Addendum No. 2

Reference: Regional Training Institute – TASS Phase 2
Utah National Guard – Camp Williams, Utah
DFCM Project No. 11020480

ISSUE DATE:	1 April 2013
RESPONSE TO:	Contractor Requests for Information & DFCM Comments
PROJECT:	**RTI TASS Complex, Phase II** **Administration & Billets Buildings** 17800 South Academy Street Utah National Guard Camp Williams **DFCM'S PROJECT #:** 11020480 **NGB'S PROJECT #:** 490444 **ARCHITECT'S PROJECT #:** 11024
OWNER:	**Utah National Guard** 12953 South Minuteman Drive Draper, Utah 84020-1726
SUBJECT:	**VARIOUS CLARIFICATIONS**
ATTACHED:	**VOLUMES A.1 & A.2**

1 EP101 LEVEL 1 POWER PLAN
1/8" = 1'-0"

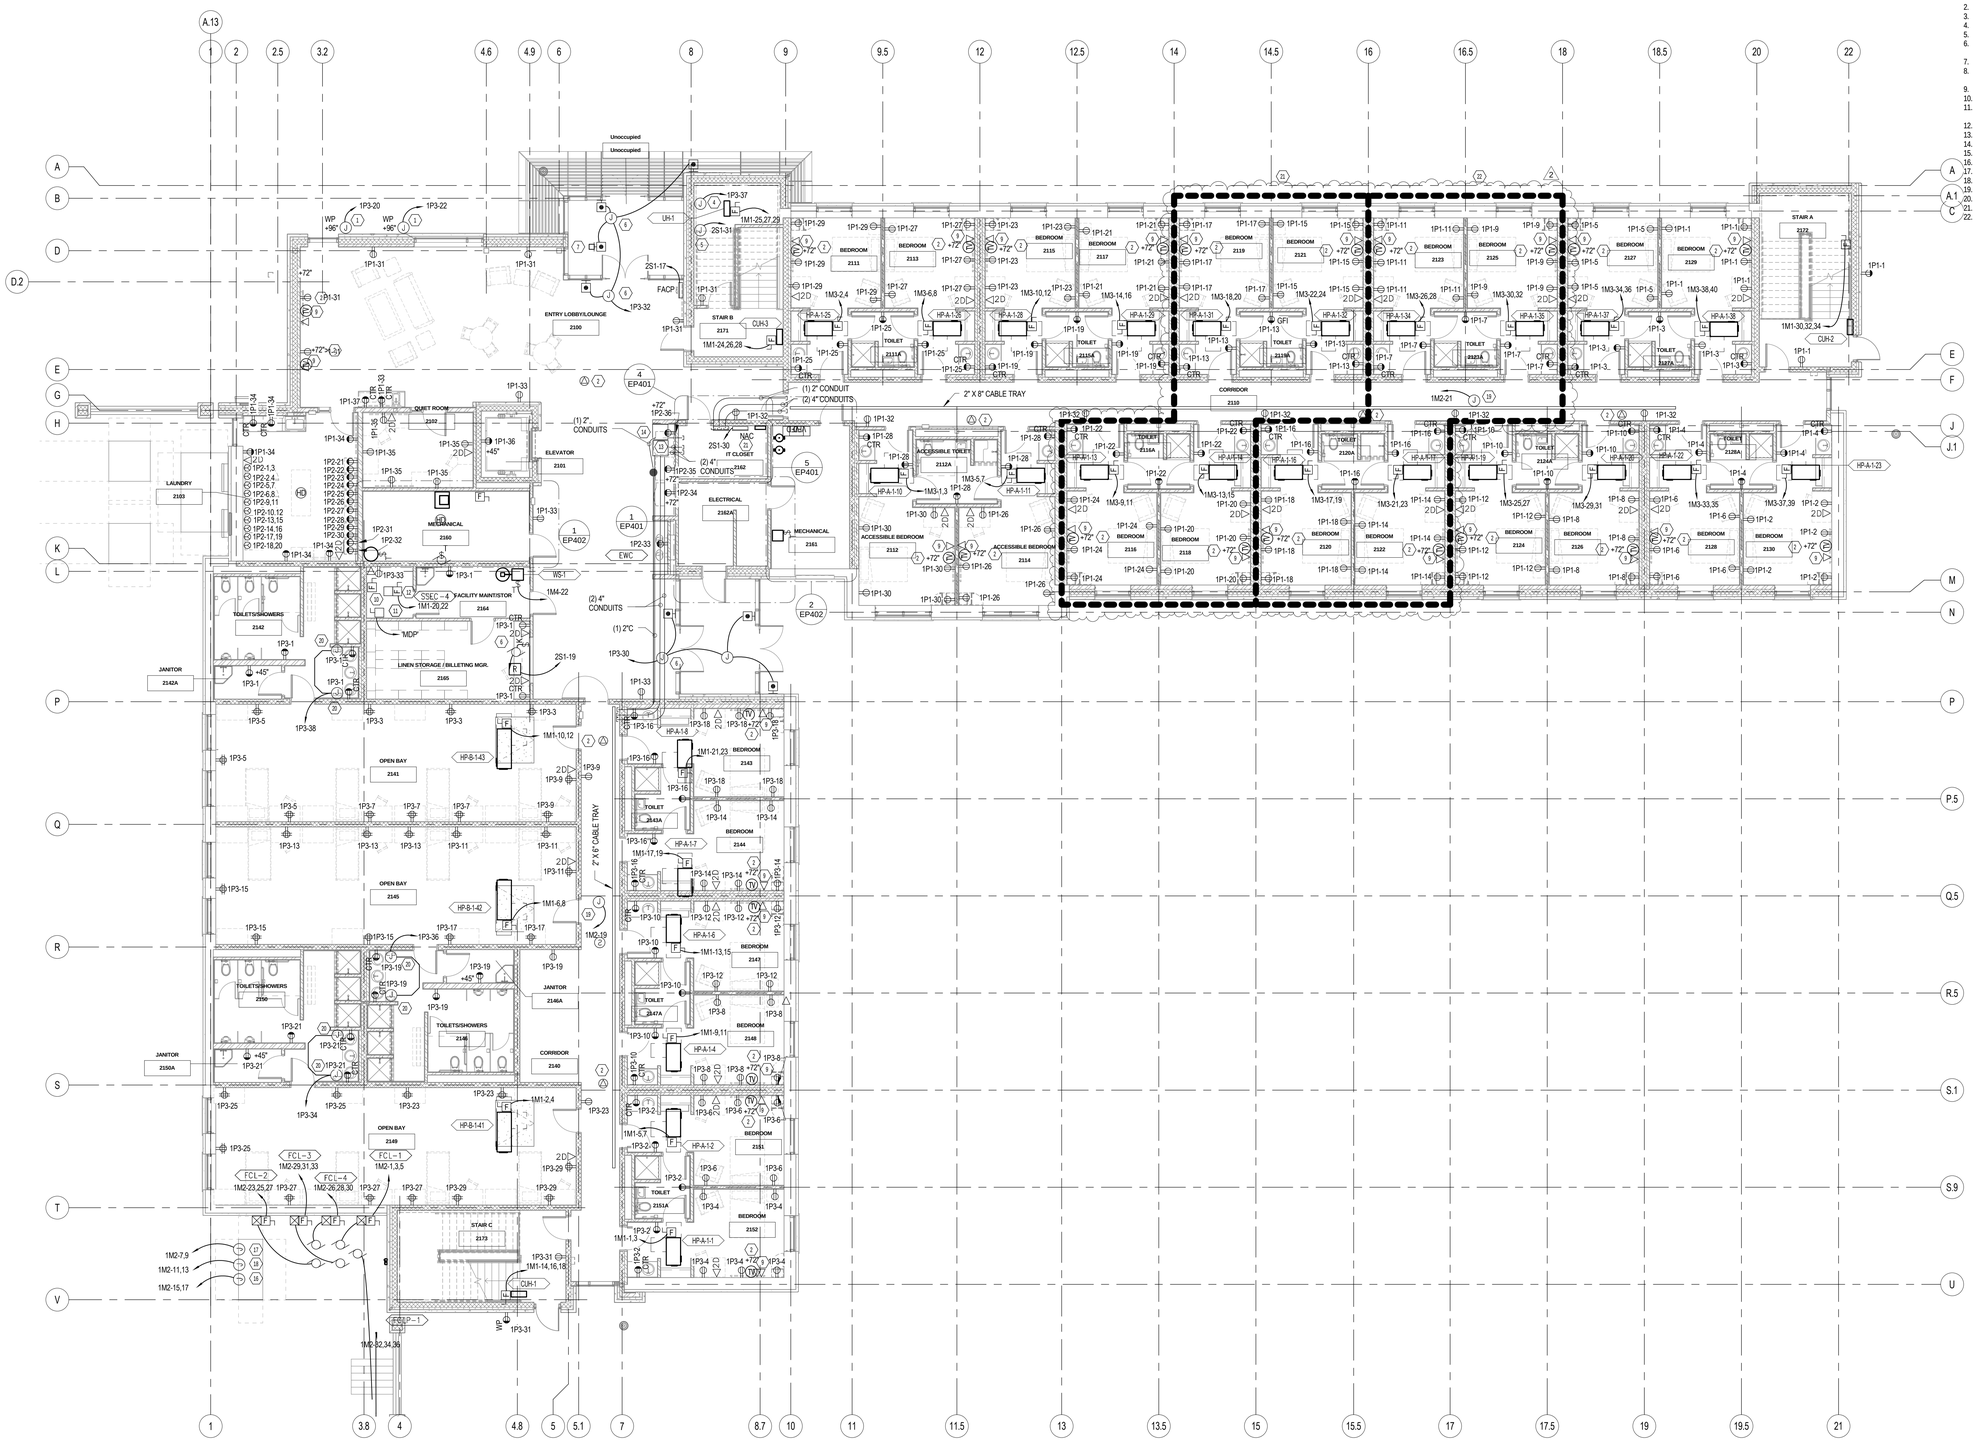
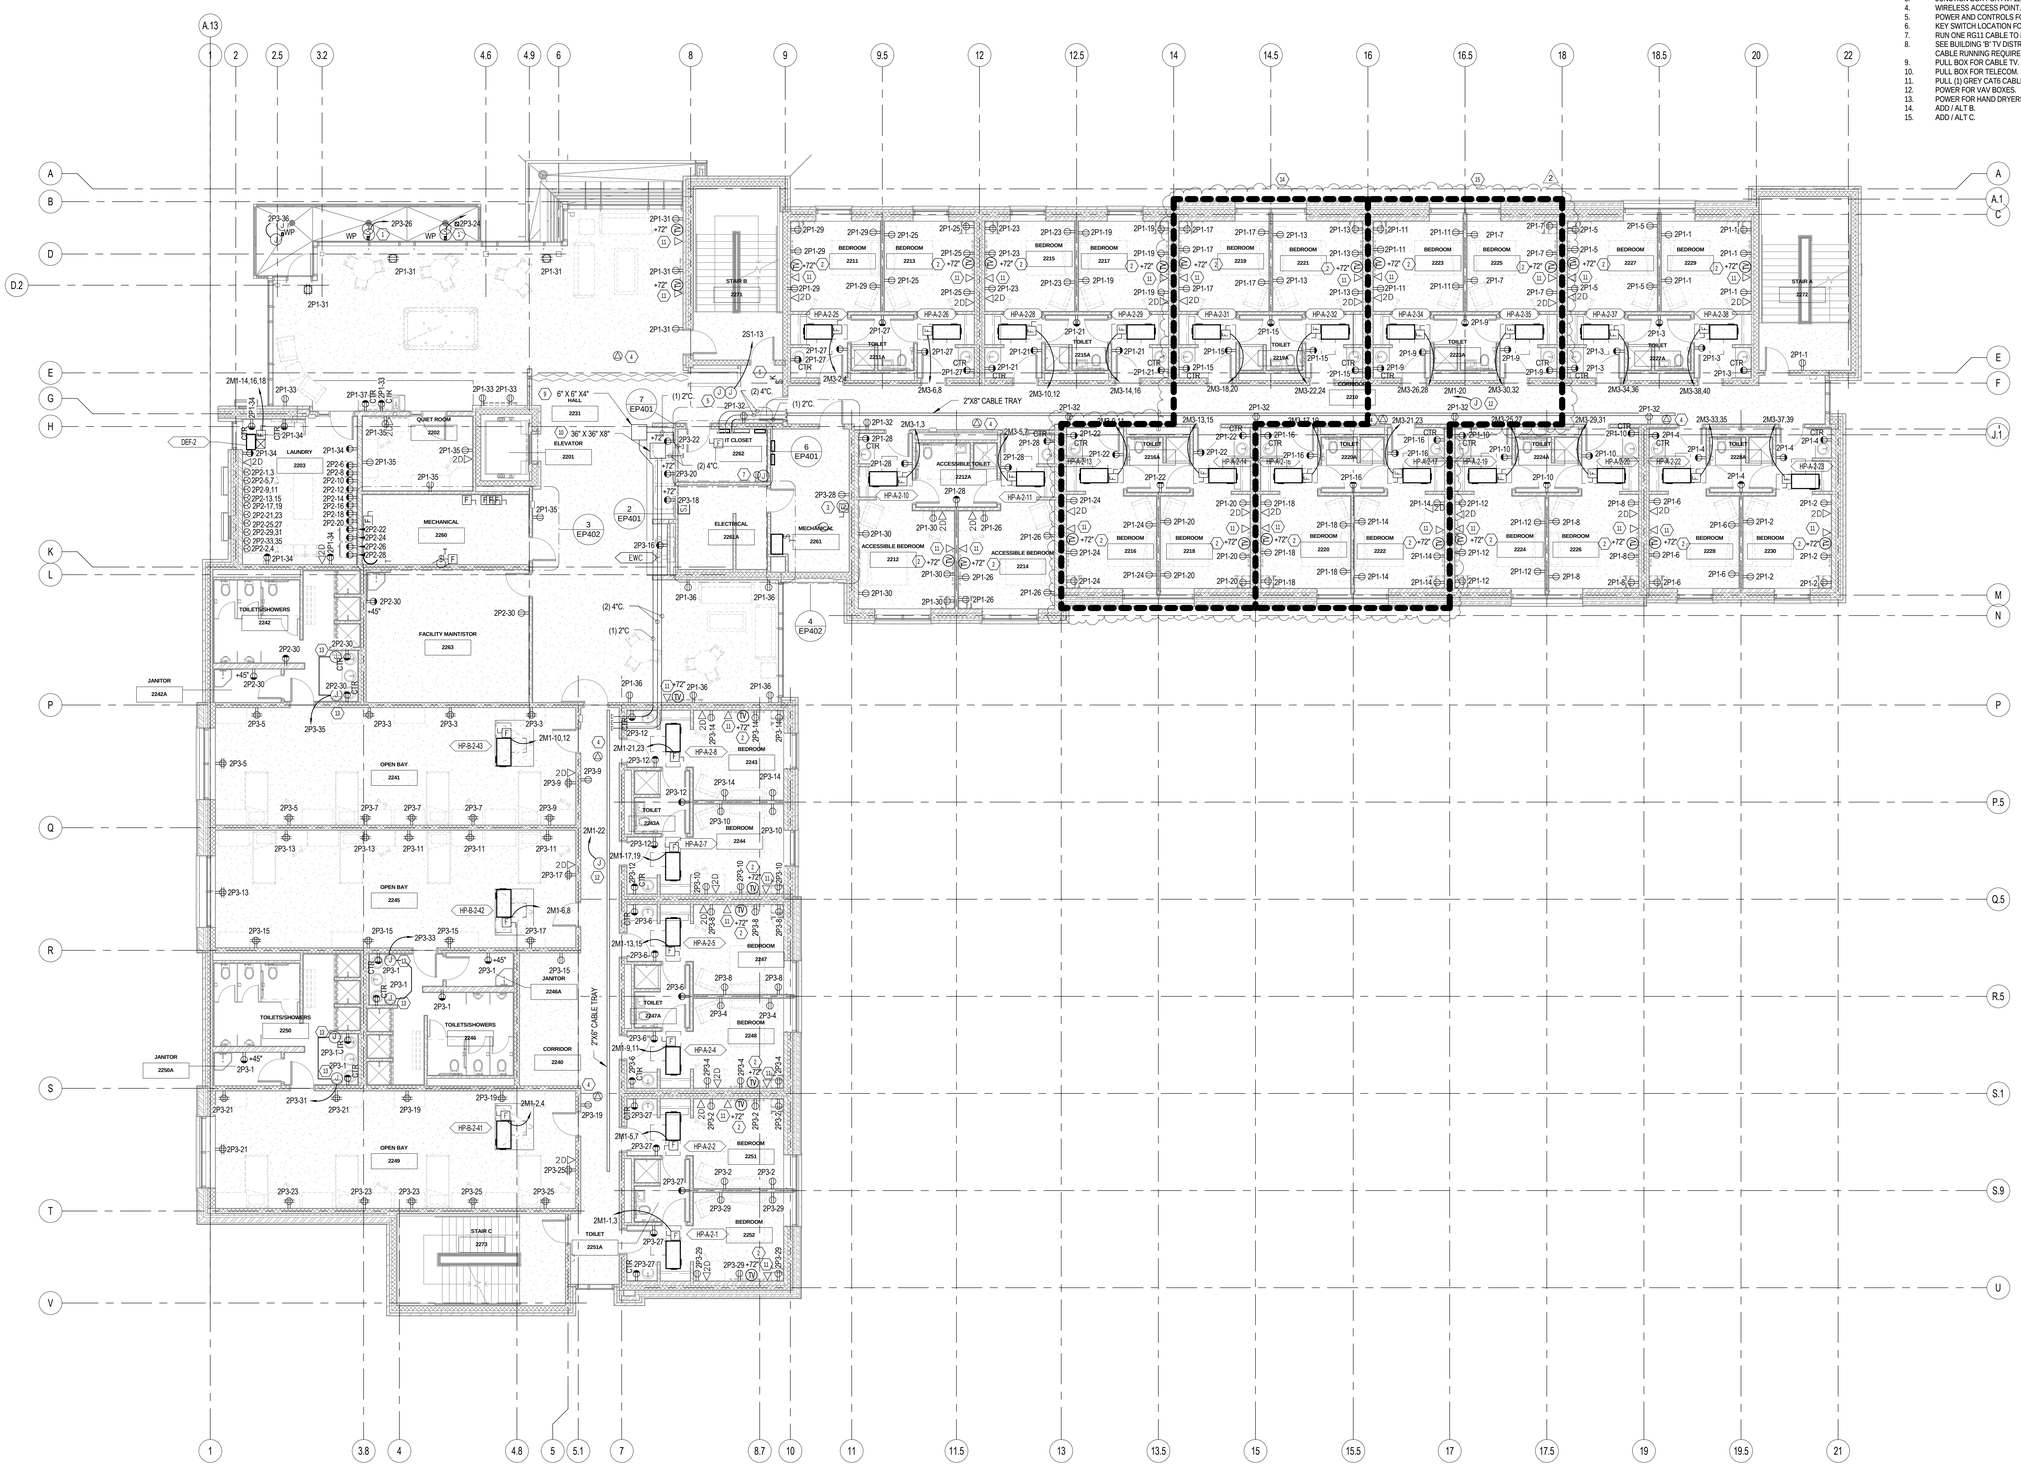
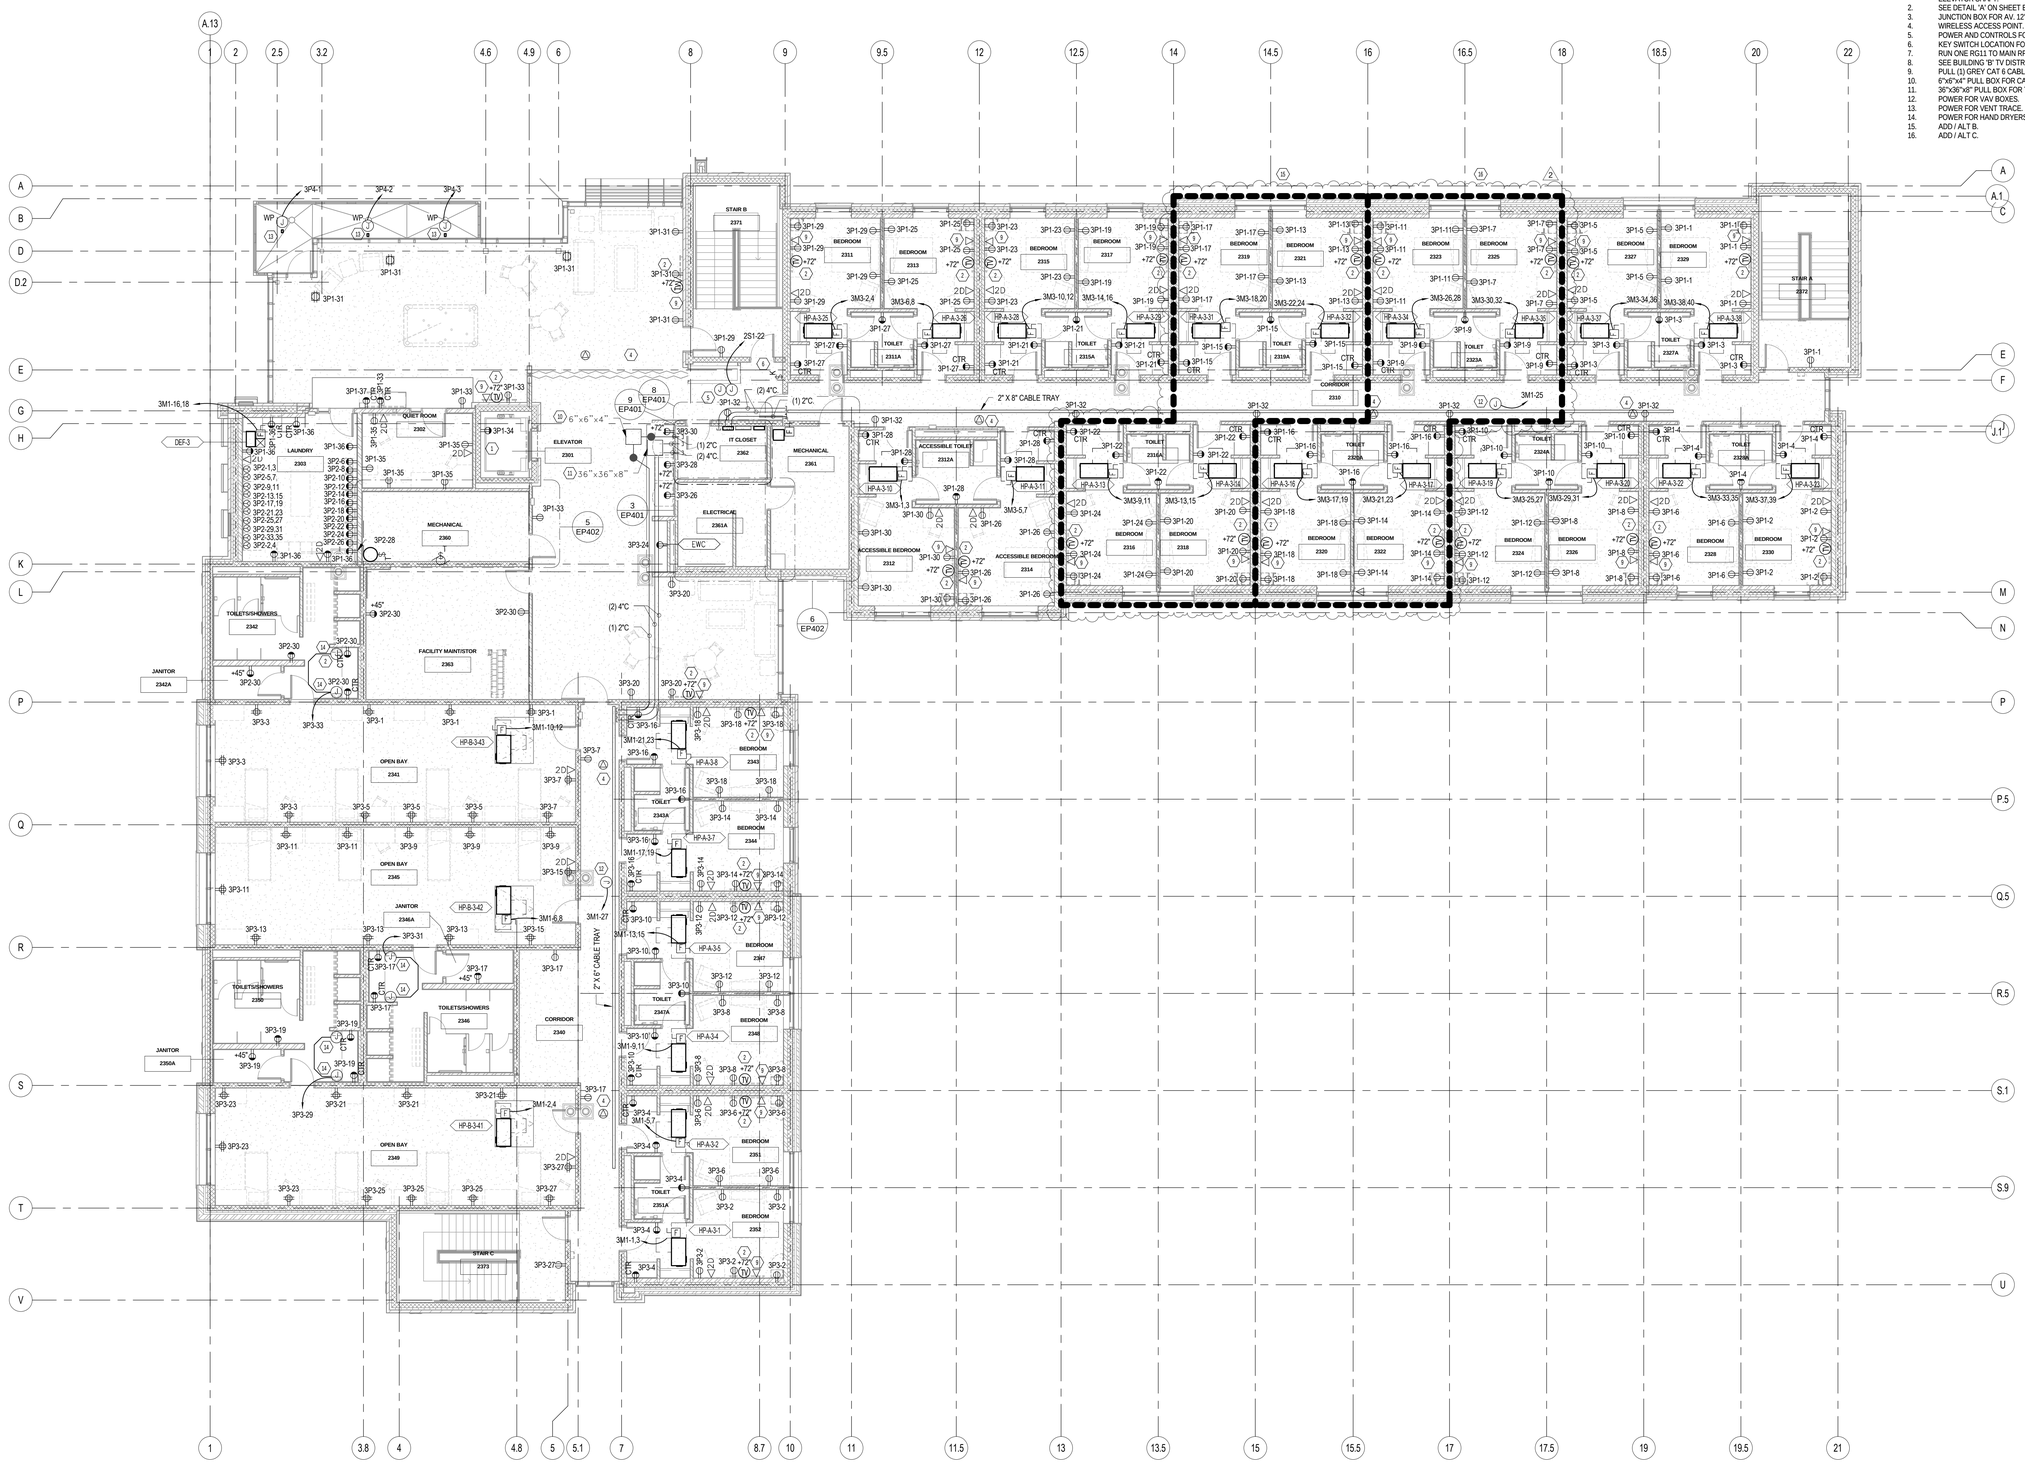
Item #	Sheet(s)	Amendment
B7.01	EL101, EL102, EL103, EP101, EP102, EP103	**REVISE** sheets to indicate areas associated with Add/Alt #2 and #3, as shown in sheets provided.
B7.02	EP601	**DELETE** keyed note #1.
